**Service Letter**

**Number: L00-21A**

**Replaces ServL00-21**

**Subject:** High Chrome replacement exhaust valve guides for Lycoming engines.

FIGURE 1

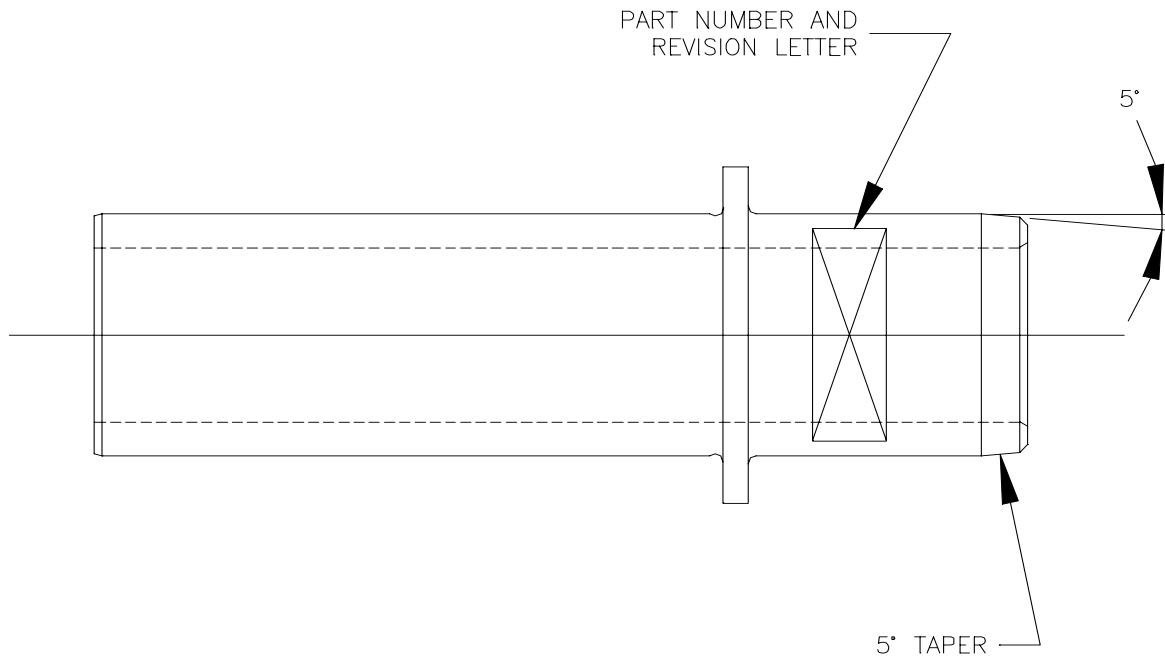
The High Chrome guides may be identified in two ways. First, the guide is machined with 5° taper at the top (rocker box) end, as shown in Figure 1. The second method is by the part number and revision letter, which is metal stamped on the upper, outside diameter. The location is also shown in Figure 1.
